Minutes Final

Girdwood Trails Committee Special Meeting

Tuesday, January 18, 2022 7:00PM

1. Introduction and discussion of draft Girdwood Trails Master Plan reviewing recommendations brought forward from GTC members

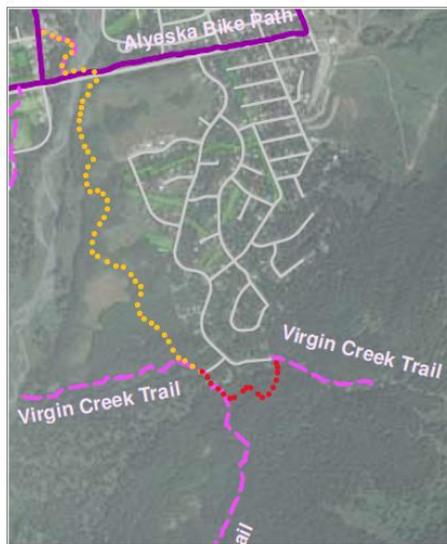
- Proposed Motion: Vote to adopt the Girdwood Trails Master Plan as it is now (i.e. after incorporation of the votes on recommendations ending at the January 4, 2022 meeting), and add any new proposals that are voted on and accepted by GTC as an additional appendix to the Plan. (Raymond-Yakoubian)
- Proposed change: Title - Virgin Creek Falls Trailhead. Keep bullet points 1,2,3
Add bullet point 4: Upon completion of the study and review of the suggested alternatives by GTC there will be implementation of the preferred option. (Tenny)
- Proposed change: Add 3-5k loop class 4 trail north of T14. (Thomas)
See map below for rough drawing of this concept.

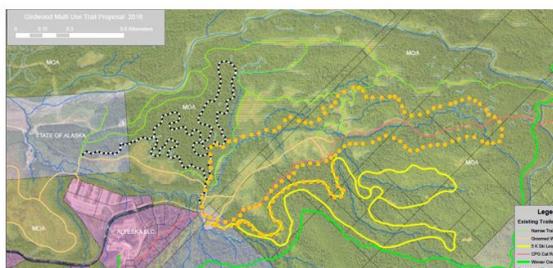
- Proposed Motion: Vote to connect the Upper Joe Danich trail with the Virgin Creek Trail. (Essex). (see map below)

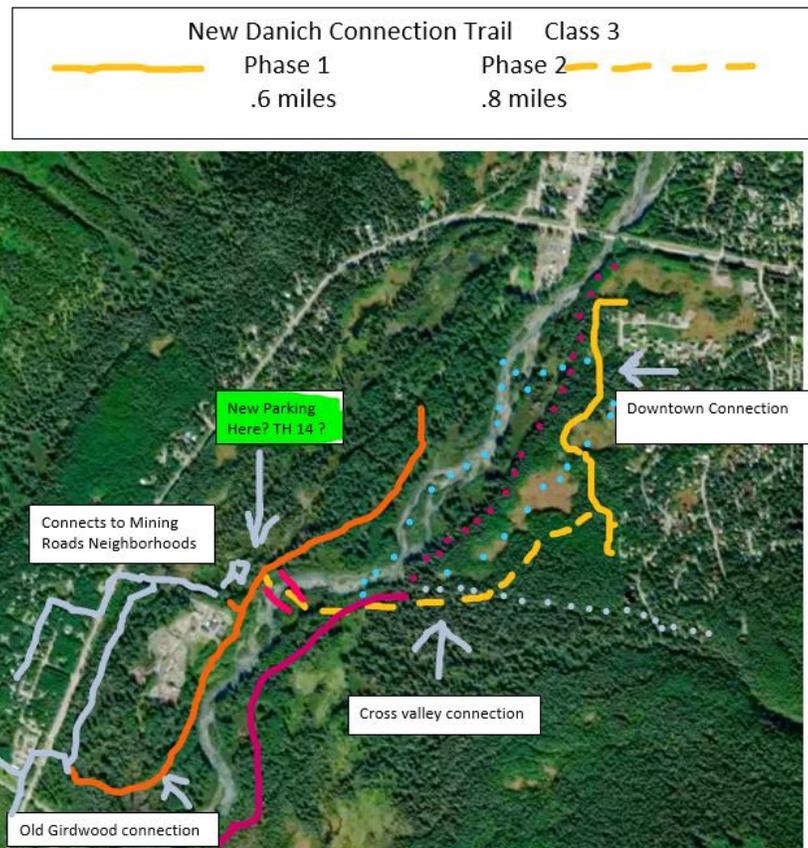
- Proposed Motion: Add to the draft plan a new class 3 trail traversing parcel 6-036 and other nearby lands generally following the route that is indicated on the attached map. (P Crews)
- Proposed Motion: Add to the draft plan a new site to locate bridge 1. Remove from the draft plan the old location of bridge 1. Select the new location of bridge 1 to correspond with the southern termination of the trail described in motion 1. (P Crews)
- Proposed Motion: Add new trailhead parking #14 near the southern termination of the trail described in motion #1. (P Crews)
